Access Compliance Report Public Rights-of-Way (Pedestrian Signals)

Intersection ID: N/A	Main Street:	Cross Street: N/A	Location: N/A
ADA ID: 8D7AFBFE4E3A	Signal Type: One Push Button-Non APS	Overall Compliance: No	Severity Score: BTN 1: N/A BTN 2: N/A No BTN: N/A
Codes/Mitigation Info/Possible Solution		Field Measurements/Component Compliance

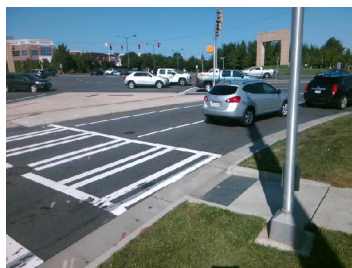
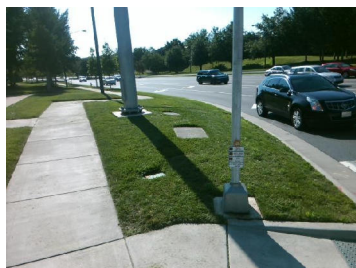
PROW/ADA: R404.2, R404.3, R404.7.3

Possible Solutions: Provide Push Button Extension. Remove and Replace Clear Space.
